**Subject: Safety Recall 04V-106
(Ford Number 04S12)**

SUBJECT: **DEMONSTRATION / DELIVERY HOLD: Safety Recall 04S12:**
All 2000 Model Year Taurus and Sable Vehicles; Also, Certain 2001-2003 Model Year
Taurus and Sable Vehicles Equipped with Adjustable Pedals
Stop Lamp Switch and Wire Harness Replacement

**ALL 2000 MODEL YEAR TAURUS AND SABLE VEHICLES AND
CERTAIN 2001 THROUGH 2003 MODEL YEAR TAURUS AND SABLE VEHICLES
EQUIPPED WITH ADJUSTABLE PEDALS —
STOP LAMP SWITCH AND WIRE HARNESS REPLACEMENT**

FIGURE 1

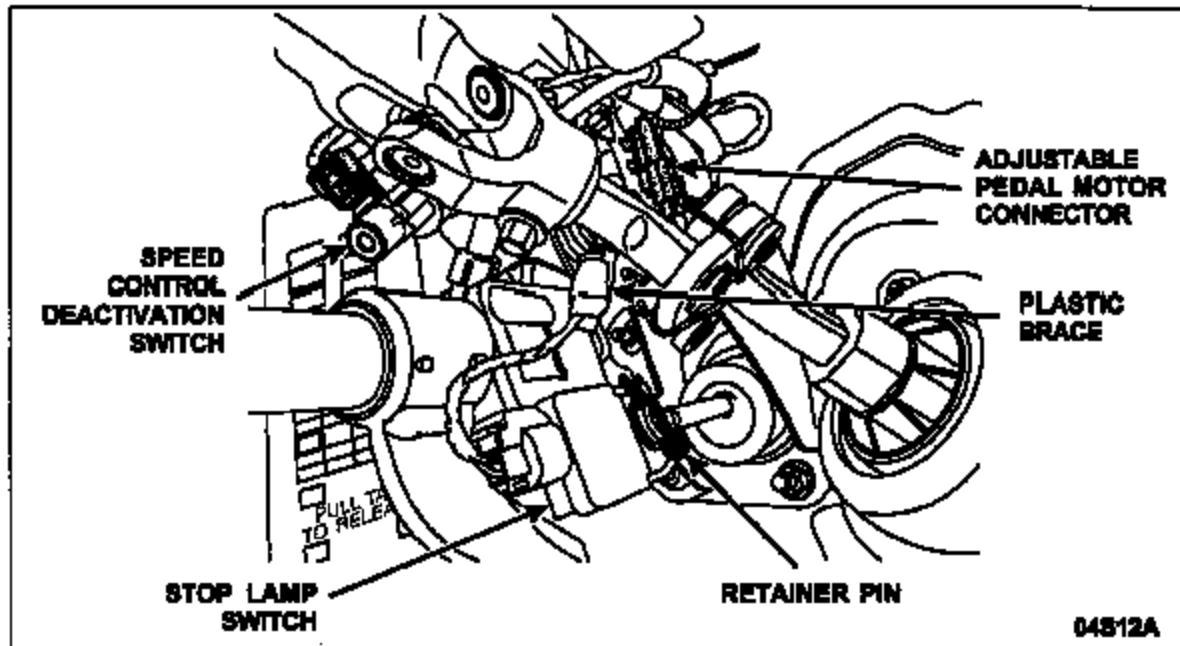
1. Install a memory saver and disconnect the battery negative cable.
2. Position the stop lamp switch wire harness assembly down the left side of the steering column for easier access to the repair area as follows: See Figure 1.
 - a) Remove the stop lamp switch retainer pin. Retain the pin for reuse.
 - b) Remove the switch and the plastic grommet from the brake pedal/master cylinder pushrod. Discard the grommet.
 - c) Disconnect the adjustable pedal motor connector, if equipped, and the speed control deactivation switch.
 - d) Disengage the harness push-pin retainers (securing the plastic brace).
 - e) Pull the harness out of the steel retention clip (located on the brake pedal bracket above the steering column on adjustable pedal vehicles only).
 - f) Remove any tie straps that secure the harness.
 - g) Position the harness over the steering column and down.

FIGURE 2

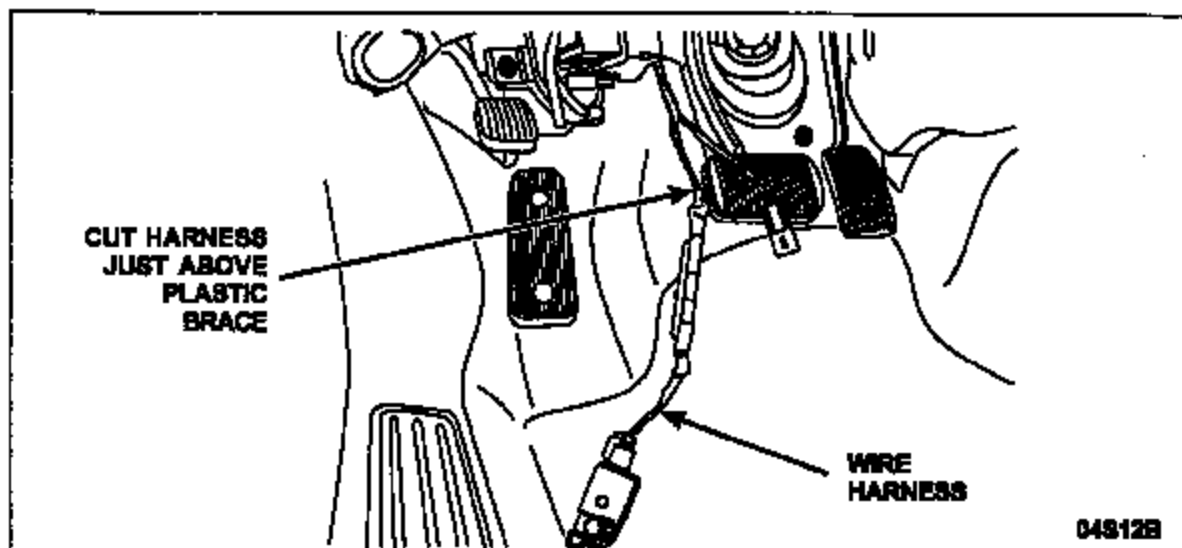
3. Cut off the stop lamp switch wire harness above the plastic brace and discard the switch and harness. See Figure 2.

FIGURE 3

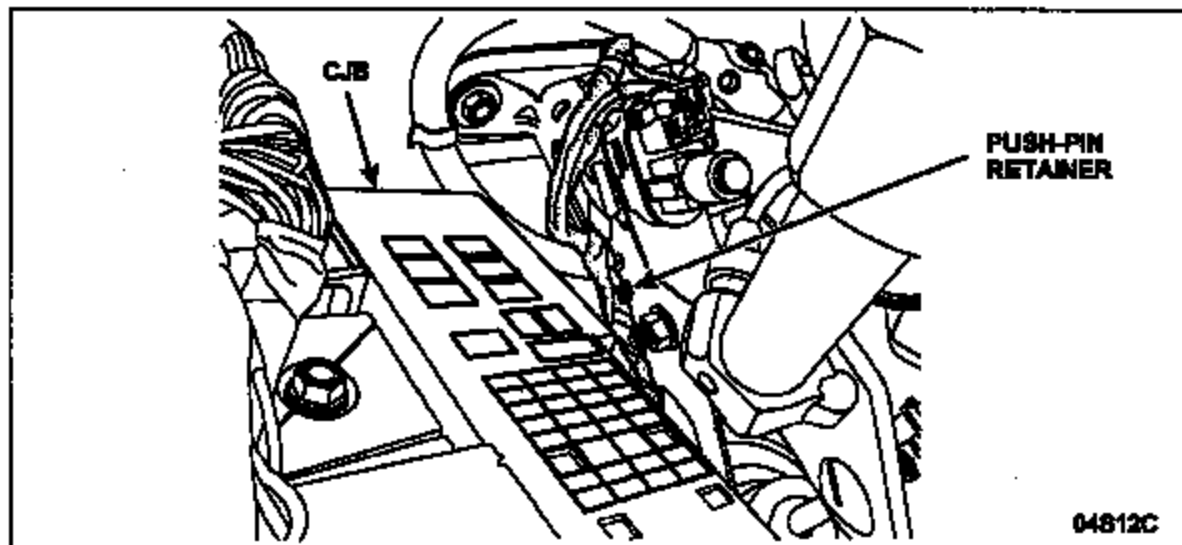
4. It is possible that on some vehicles that have had the TSB performed, the splice may be located very high on the harness and access can be limited. In these situations, disengage the harness push-pin retainer located on the left side of the brake pedal bracket (next to the central junction box [CJB]). This will provide enough slack in the harness to allow better access to the repair area. See Figure 3.

FIGURE 4

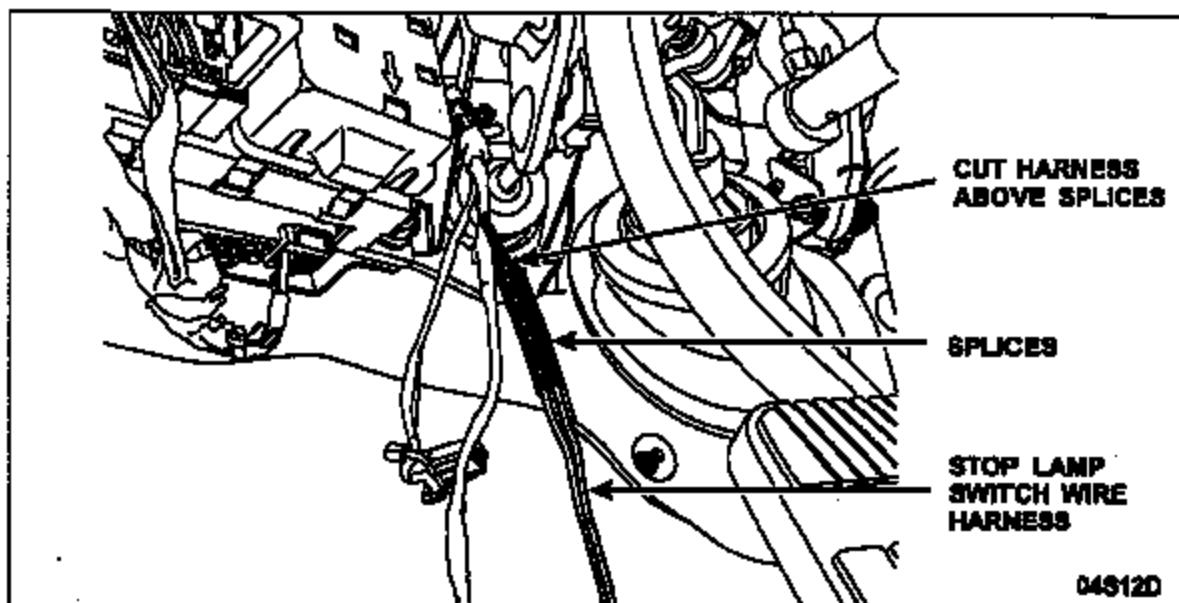
5. Remove enough tape to expose the repair area. Then cut off the harness above the splices, leaving as much of the vehicle harness as possible (the cut off section will include the switch, harness and the TSB-installed splices). See Figure 4.

FIGURE 5

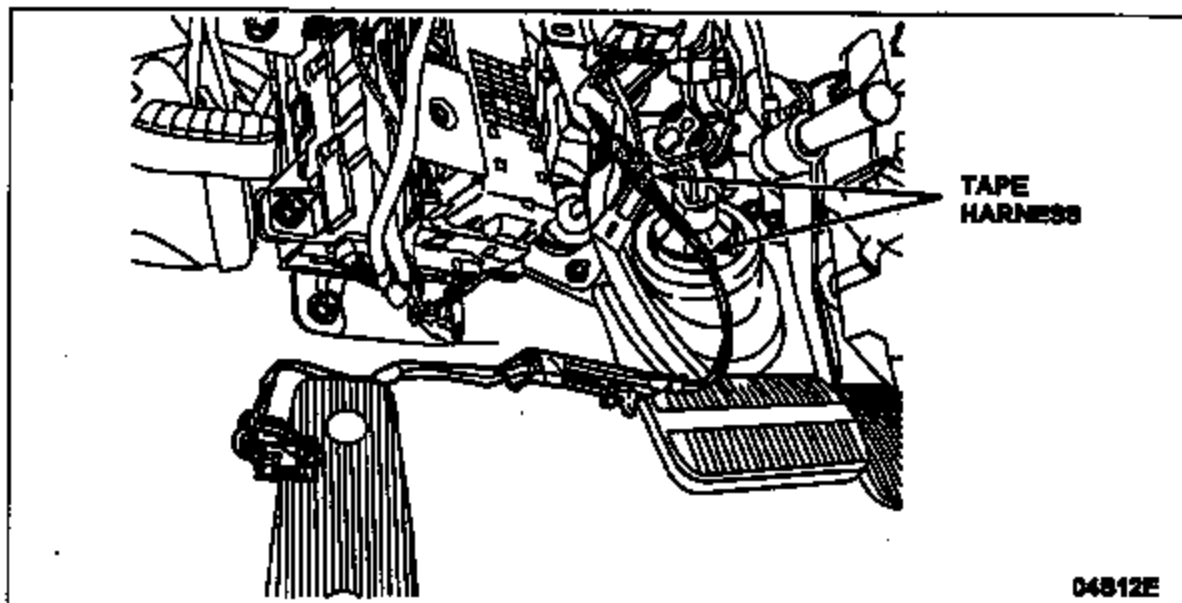
10. Using vinyl electrical tape, secure the butt splice and the harness wires together in two or three locations. See Figure 5.

FIGURE 6

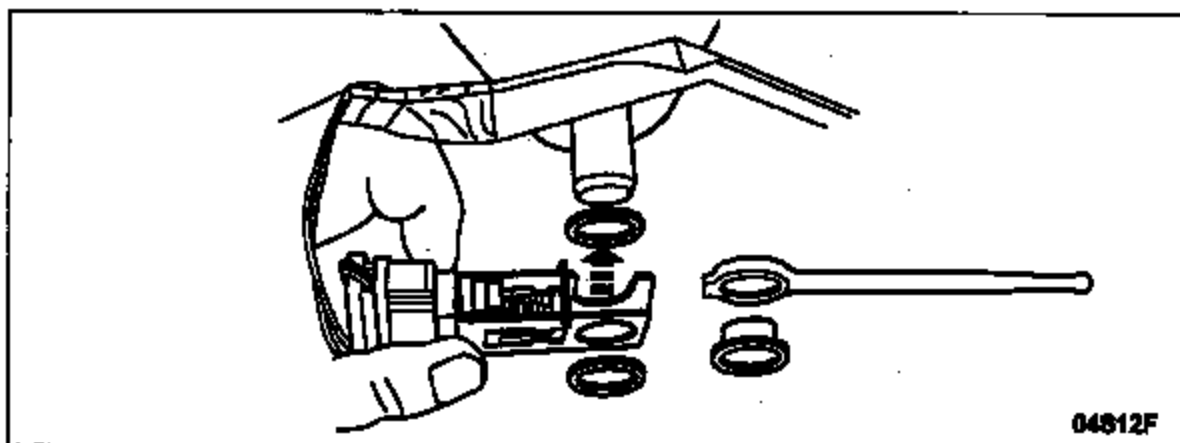
11. Install the new stop lamp switch as follows (See Figure 6):
- Install the new plastic grommet onto the master cylinder pushrod.
 - Place one new plastic washer in the brake pedal arm post, then connect the pushrod to the post.
 - Position the new stop lamp switch onto the post, then install the other new plastic washer.
 - Install the retainer clip.

FIGURE 7

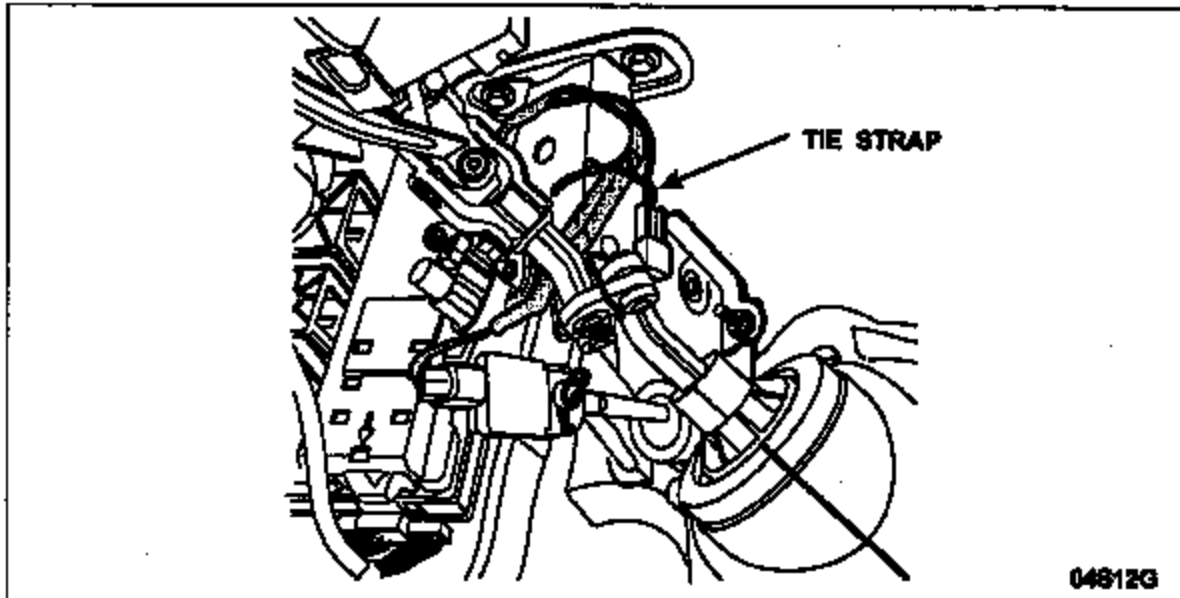
12. Position the harness back over the steering column and into place, then secure the push-pin retainer(s) to the brake pedal bracket. Be sure the excess wiring is positioned so it does not interfere with any moving components. Use the supplied tie straps to secure the wires. Install one to secure the plastic brace to the brake pedal bracket and the other to secure the wires as necessary. See Figure 7.
